LINCOLN CITY/LANCASTER COUNTY PLANNING STAFF REPORT

for March 15, 2006 PLANNING COMMISSION MEETING

PROJECT #: Annexation #06004
 Change of Zone #06016
 Use Permit #06003 - Southlake

Subject: Southlake PUD Change of Zone #06015, AN #06004

P.U.D. GENERAL SITE NOTES

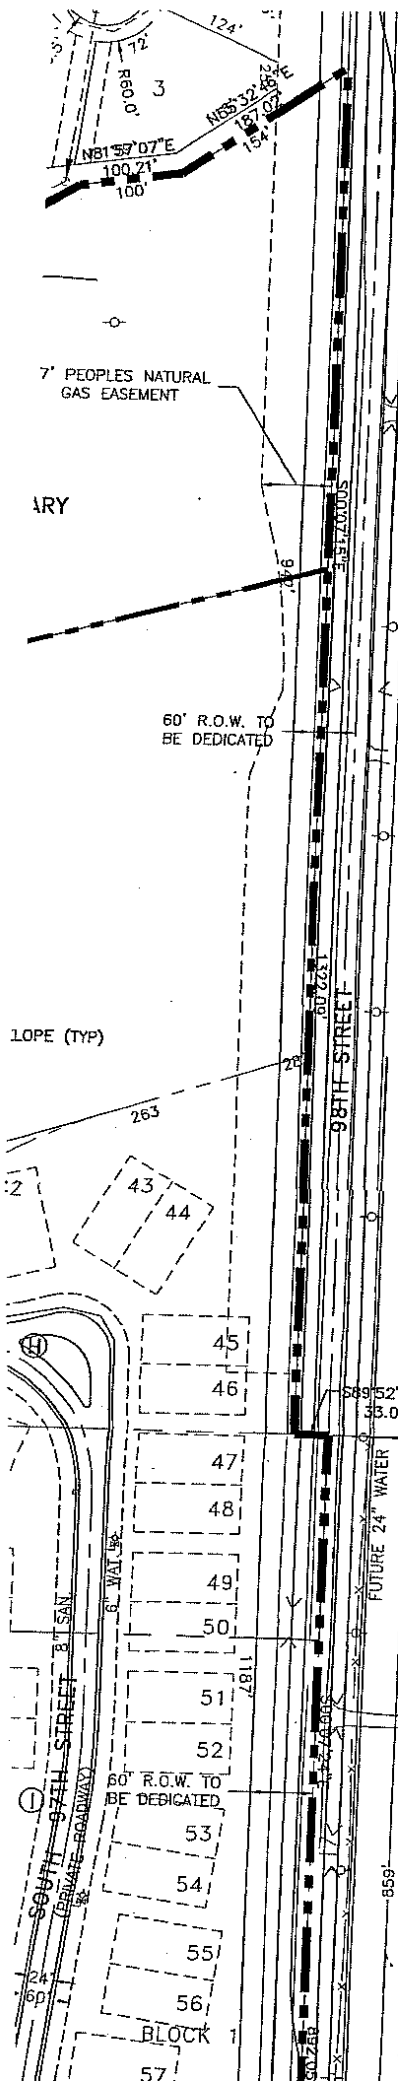
2.1.1.1 Delete General Notes #12, 15, 16, 18, 25, 29, and 33.

- 2.1.1.8 Revise General Note #15 to state "LOT DIMENSIONS ARE APPROXIMATE AND MAY VARY AT TIME OF FINAL PLAT."
- 2.1.1.9 Revise General Note #24 to state ".....IN ACCORDANCE WITH LINCOLN MUNICIPAL CODE TITLE 27."

- 2.1.1.10 Revise General Note #26 by deleting "AS AMENDED BY THE SOUTHLAKE REGULATORY MODIFICATIONS."
- 2.1.1.11 Revise General Note #28 to read as ".....STREET TREES AND REQUIRED LANDSCAPE SCREENS TO BE REVIEWED....."

- 2.1.1.12 Revise General Note #31 to state "MINIMUM DISTANCE BETWEEN BUILDINGS IN THE CUP SHALL BE AT LEAST 20'."
- 2.1.1.13 Delete the word "TOWNHOUSE" from General Note #36.

- 2.1.1.14 Revise General Note #44 to state "LOTS ADJACENT TO SOUTH 98TH STREET WILL NOT BE FINAL PLATTED UNTIL THE STREET IS IMPROVED TO CITY STANDARDS."

- 2.1.1.15 Separate General Notes #15, 30, 35, 37, 38, 39, 43, and 47 into a separate table labeled 'Waivers'.

PRELIMINARY STREET PROFILES
SOUTHLAKE P.U.D.

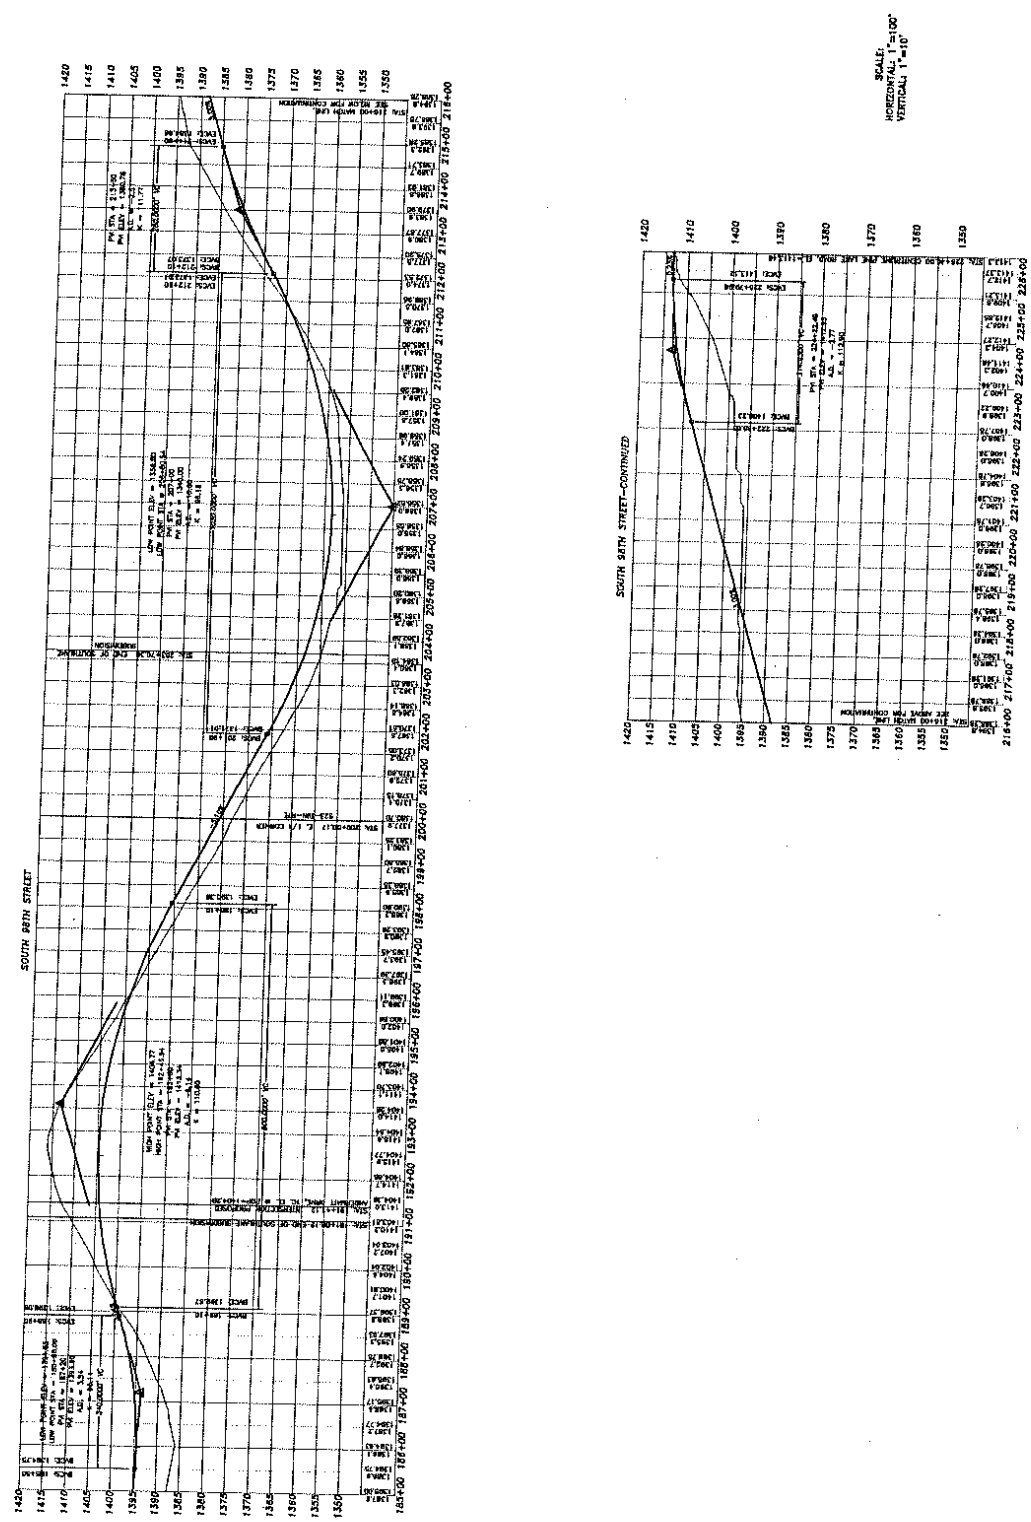
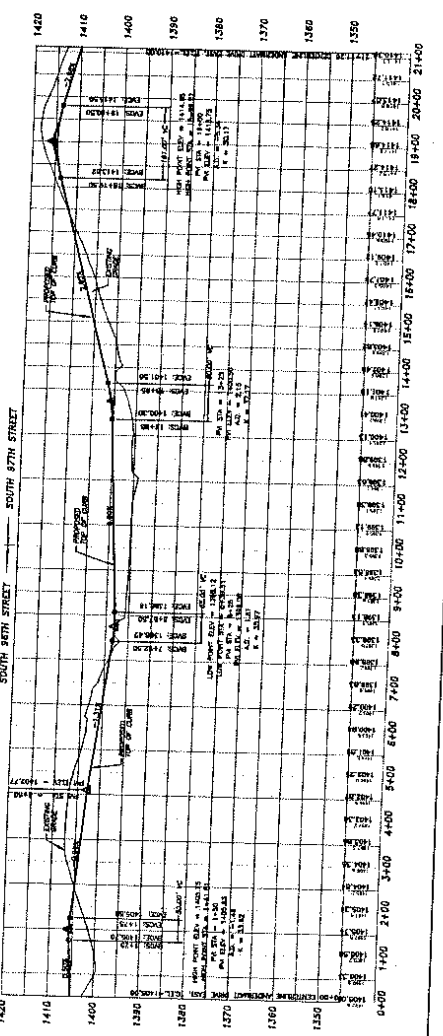
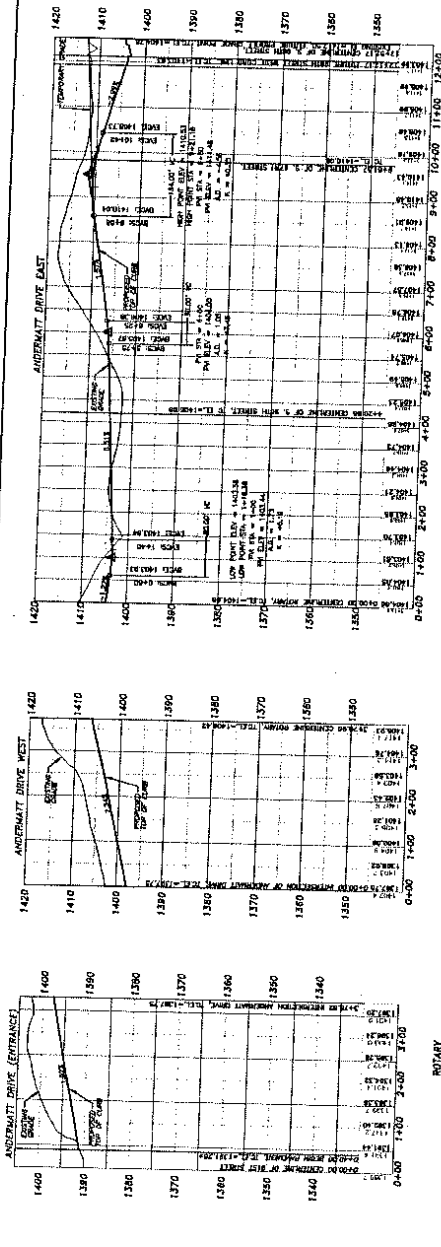
- **Sanitary Sewer** - The following comments need to be addressed.
 - (1.1) The location of the proposed sanitary sewer between South 96th Street and South 94th Bay is unacceptable. The plans show the sewer to be located along the center of the dam for the proposed permanent pond in Outlot B. The plans need to be revised to show the sewer and easement located in a clear and flat area outside of the influence of any structural elements of the pond dam. This pond is not a required feature for the development as detention is accounted for in the existing Korver Lake at the north end of the project. If the sewer is to remain in its proposed location, the grading plan needs to be revised to show the pond dam shifted further south so as to not affect the sewer main or associated easement.

- (1.2) The sanitary sewer shown in Outlot A should be removed or relocated. It is not desirable to locate public sewer across a private parking lot. Routine and emergency maintenance would require City vehicles and equipment to take up parking stalls and disrupt operations of the businesses. A sewer can be shown on the west side of Outlot A along South 91st Street to serve future Lots 1 and 2 while future Lots 3 and 4 could be served from the public sewer in Andermatt Drive or the sewer located between Lots 4 and 9.

- (4.4) Public Works approves the requested waiver of design standards for tangent length between two horizontal curves.
 - (4.5) Public Works does not approve the proposed geometry for Andermatt Drive from 91st Street to 98th Street. The traffic study submitted does not provide sufficiently detailed information for the commercial and residential areas to the south to properly determine the adequacy of the proposed street system. Also, the status of the intersection of 98th Street with Highway 2 is not known and will most likely affect desired intersection geometry and locations along 98th Street including the Andermatt Drive intersection shown on this plat.
